SERVICE MANUAL

US Model

SERVICE MANUAL

SUPPLEMENT

SCHEMATIC DIAGRAM

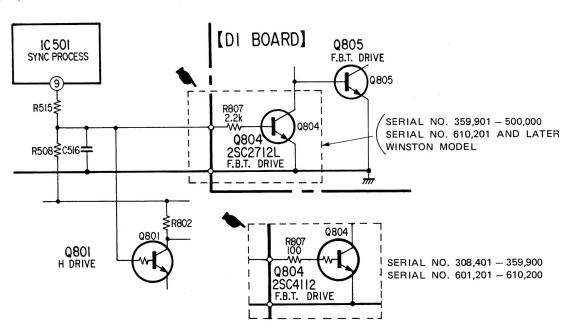
1. D1 Board change

D1 board of FD-10A new type (see supplement No. 1) has been changed. (Part number's suffix is 23.)

The mounting diagram and a part of schematic diagram for the new D1 board are given in this supplement.

: changed portion

CHANGED PARTS (against the new type described in supplement No. 1)

Ref.		o.308,401 — 359, o.601,201 — 610,		Serial No.359,901 — 500,000 Serial No.610,201 and later WINSTON model			
No.	Part No.	Description	Remarks	Part No.	Description	Remarks	
JR804			DELETED				
Q804	8-729-806-99	TRANSISTOR 2SC4112		8-729-100-66	TRANSISTOR 2SC1623	CHANGED	
R807	1-216-025-00	METAL CHIP 100Ω 5% 1/10W	ADDED	1-216-057-00	METAL CHIP 2.2KΩ 5% 1/10W	CHANGED

MOUNTING DIAGRAM

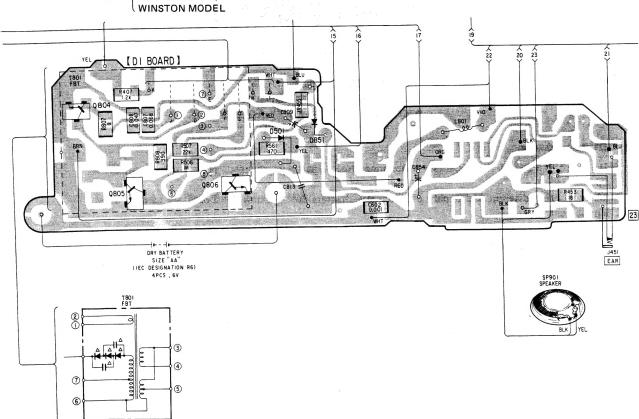
*R807

SERIAL No. 308,401-359,900 100

SERIAL No. 601,201-610,200

SERIAL No. 359,901-500,000 SERIAL No. 610,201 AND LATER 2.2k
